## SLG46880-E Errata Note

This document contains the known errata for SLG46880-E and the recommended workarounds.

Package(s)	32-pin STQFN: 4.0 mm x 4.0 mm x 0.55 mm, 0.4 mm pitch
------------	---

Figure 1. Example Data

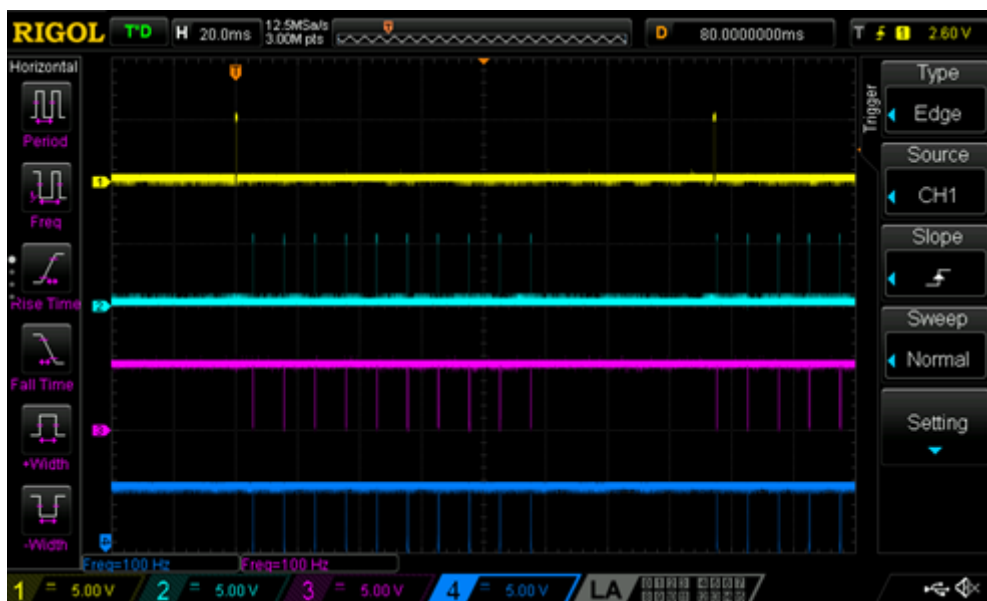
Asynchronous interaction between the CNT/DLY clock input and the I<sup>2</sup>C latch signal (generated by an I<sup>2</sup>C read command of the CNT/DLY block's count value) can result in an incorrect I<sup>2</sup>C data read. The CNT/DLY block will count accurately, but the count value transferred into the block's I<sup>2</sup>C read register might be loaded incompletely if the I<sup>2</sup>C latch signal and the clock input occur at about the same time.

The example data capture below shows ten periodic I<sup>2</sup>C reads of CNT2/DLY2 configured to count down at about 16 clocks per read. The sixth read sample erroneously shows a value greater than that of the fifth. The seventh sample reads as if the previous I<sup>2</sup>C error never occurred - the difference from the fifth sample (176) to the seventh (143) is 33 clocks or 16 clocks + 17 clocks as expected.

If the possibility of incorrect I<sup>2</sup>C data reads can't be accommodated for by external software checks, one can guarantee proper operation by stopping the CNT/DLY block's clock during I<sup>2</sup>C reads through one of the following methods: by disabling the oscillator block, by reconfiguring the CNT/DLY block's clock source, or by gating an external clock using a LUT (Look Up Table) in the signal matrix. After disabling the CNT/DLY block's clock, the count registers can be read without error. Please note that this workaround will add the I<sup>2</sup>C read and processing time to the counter's overall clock period.

The best workaround depends on the resource constraints of the application. If the oscillator block doesn't clock other logic elements within the design, a matrix output can be used to manually power down the oscillators for the I<sup>2</sup>C read. When the CNT/DLY block's clock source is routed internally from the oscillator block, I<sup>2</sup>C commands can temporarily reconfigure the CNT/DLY block's clock source registers to select "Ext. CLK. (From Matrix)." This action will disable the clock by connecting it to ground. If the CNT/DLY block is clocked from the signal matrix, LUT can be used to gate the clock during an I<sup>2</sup>C read.

Figure 2. Testing Design

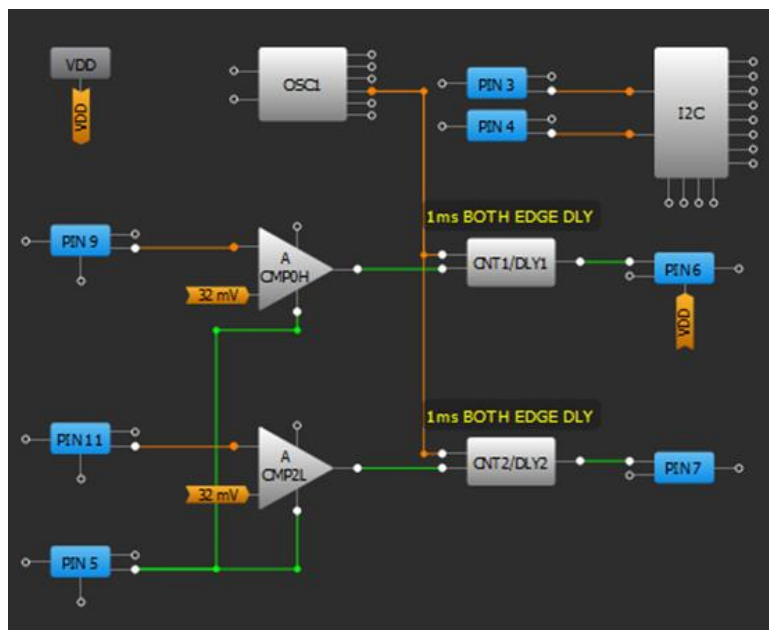
There is some noise coupling from the Vrefs of high-speed ACMPs to the low-power bandgap (BG) while the high-speed ACMPs Vref is turning on and off.

There is no issue with manually powering up the low-speed ACMPs. If you are manually powering up the high-speed ACMPs via the "PWR UP" connector, you should add a 1 ms delay to the output of all of the ACMPs used in the design.

Figure 3. Testing Design

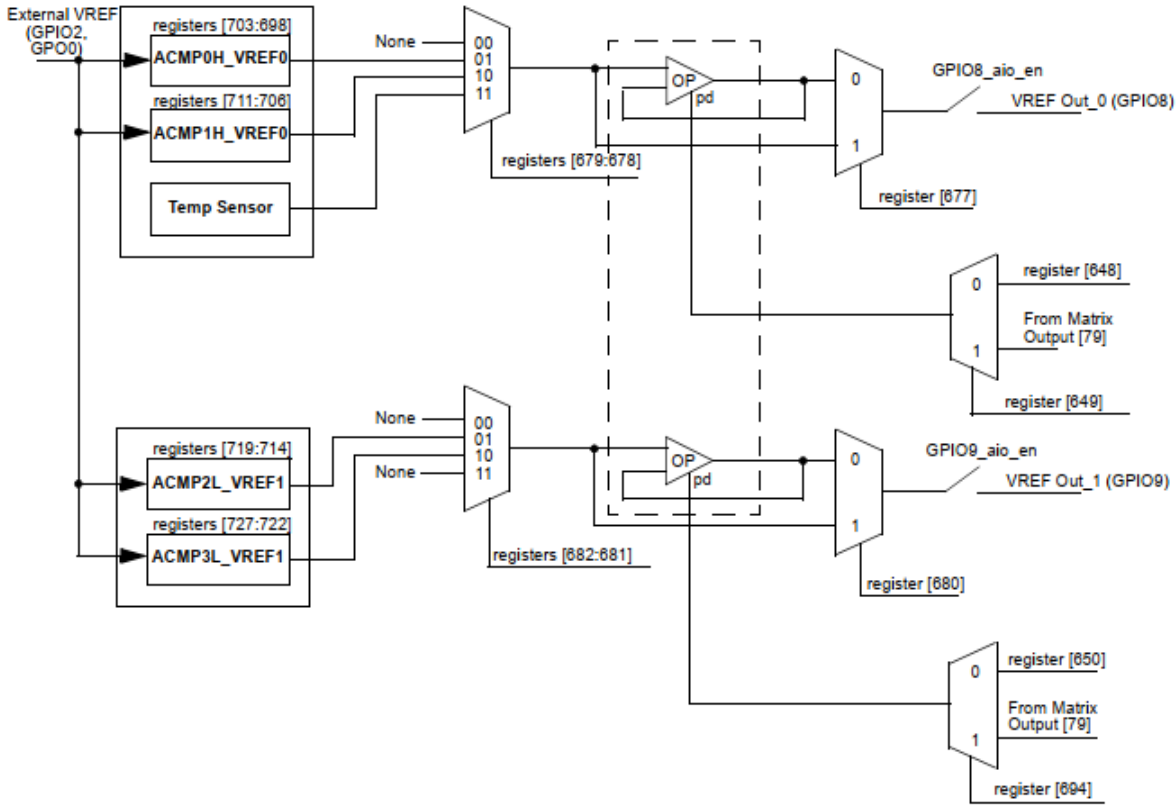
For systems where  $V_{DD} = 2.5\text{ V}$ , the Vref output buffer will be unstable if the output voltage is around  $0.5 \times V_{DD}$ .

For a system where  $V_{DD} = 2.5\text{ V}$ , bypass the buffer if the output voltage of the Vref buffer is within  $(0.5 \times V_{DD}) \pm 0.4$ . Check the Vref section of the device datasheet to see which registers need to be modified.
